ADDENDUM No. 1
Request for Competitive Sealed Proposals (CSP)
19CSP085- Renovations at Casey Elementary

CASEY ELEMENTARY SCHOOL
RENOVATIONS AT CASEY ELEMENTARY SCHOOL

ADDENDUM NO. 01: December 21, 2018

1 E2.4 **ROOF ELECTRICAL REVISED PLAN**
SCALE: 1/8"=1'-0"

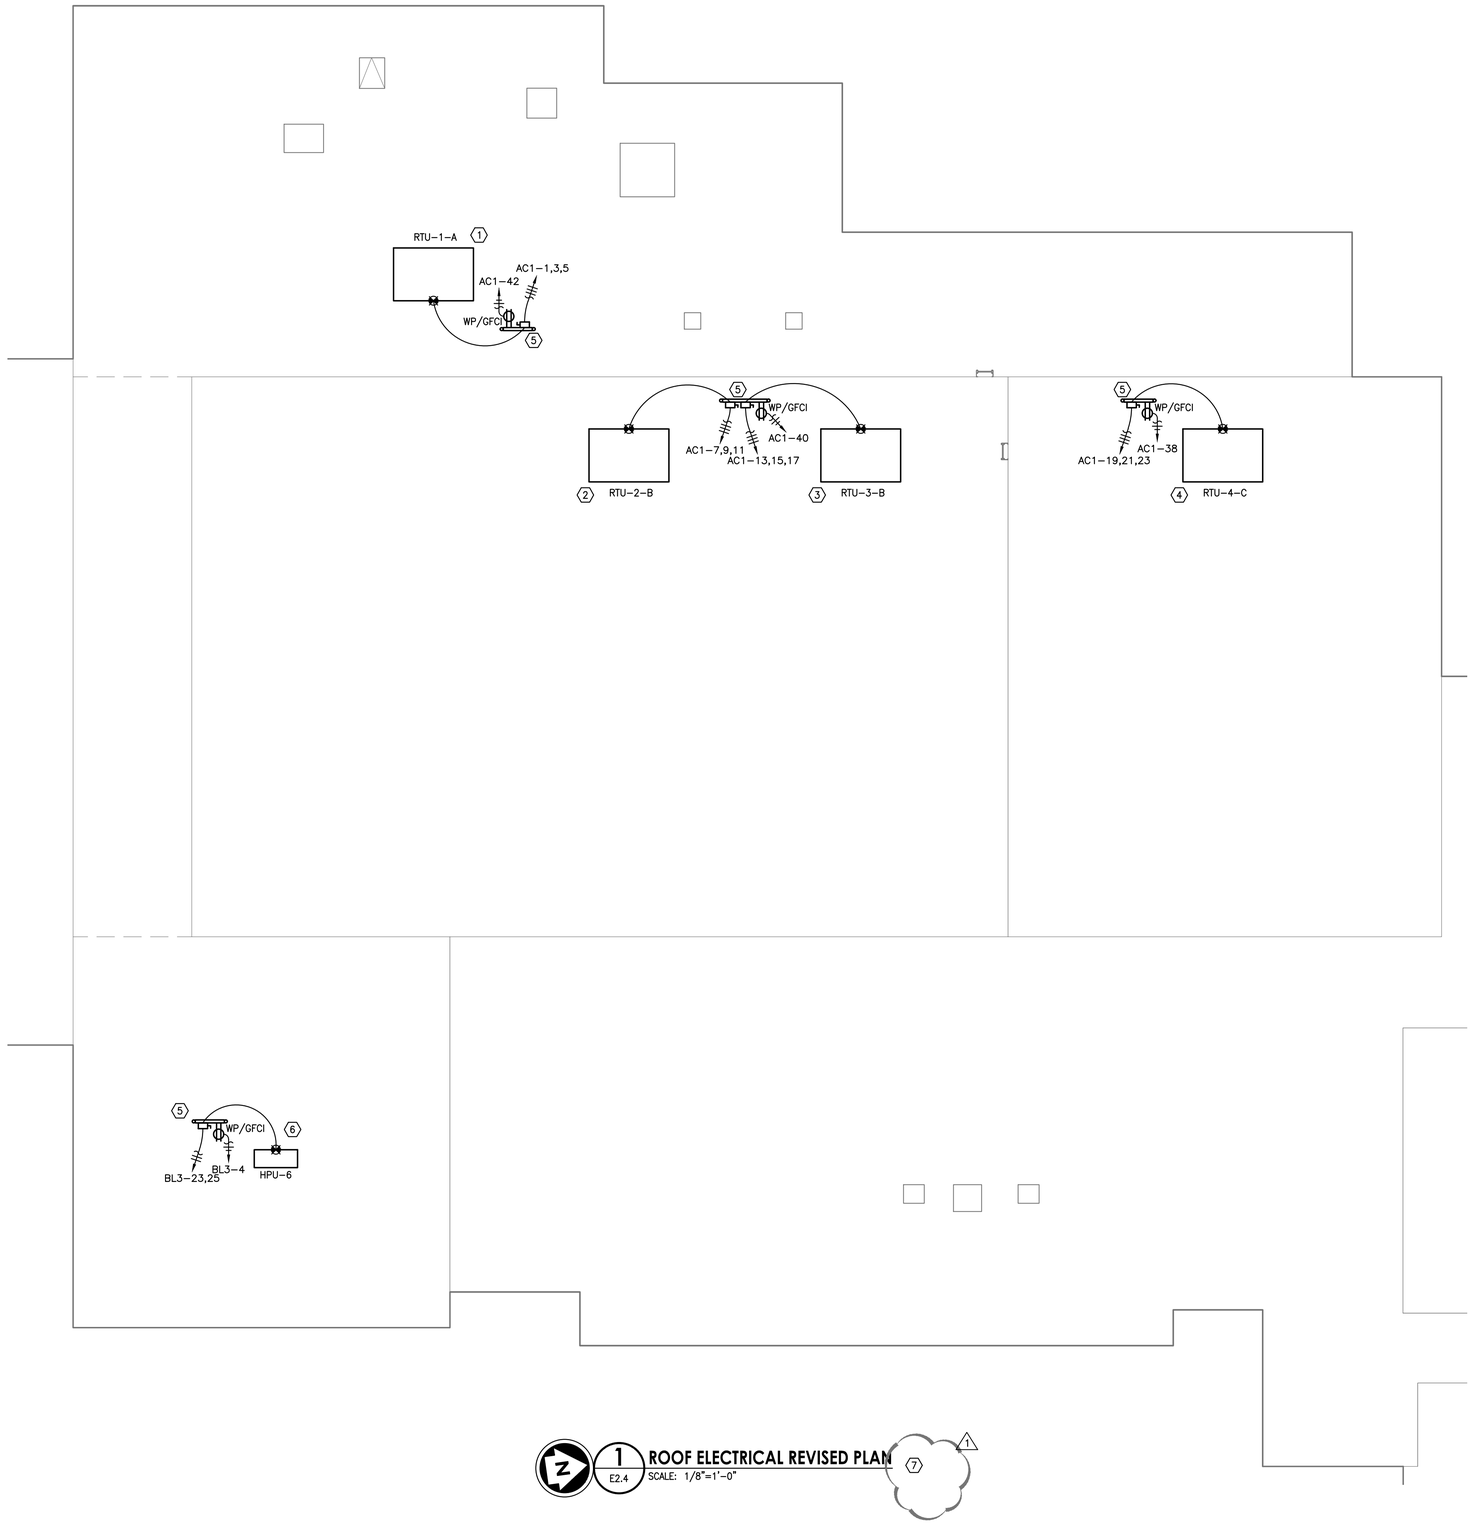
5. Sheet E2.4:
   Notes were updated to instruct the contractor that all raceways on the roof shall be galvanized rigid conduit per Electrical Specifications.

7. ALL EXPOSED RACEWAYS ON ROOF SHALL BE GALVANIZED RIGID CONDUIT AS REQUIRED IN SPECIFICATION 260533. TYPICAL.

1 E3.1 **ROOF MOUNT CONDENSING UNIT DISCONNECT RACK**
SCALE: NTS

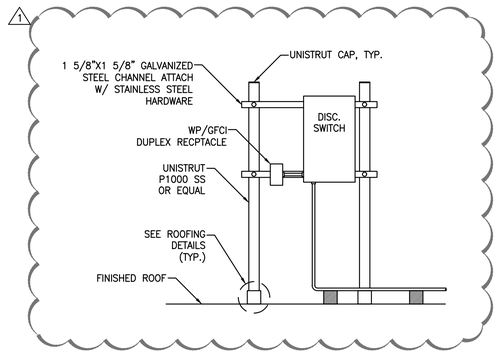
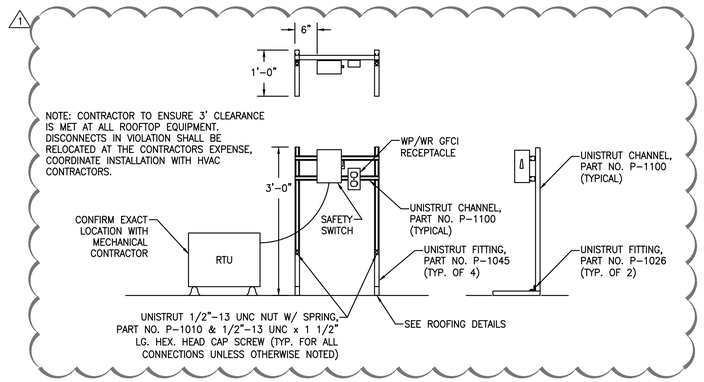
6. Sheet E3.1:
   Details 1 and 2 were updated to instruct the electrical contractor to refer to the roofing plans for electrical rack mounting details.
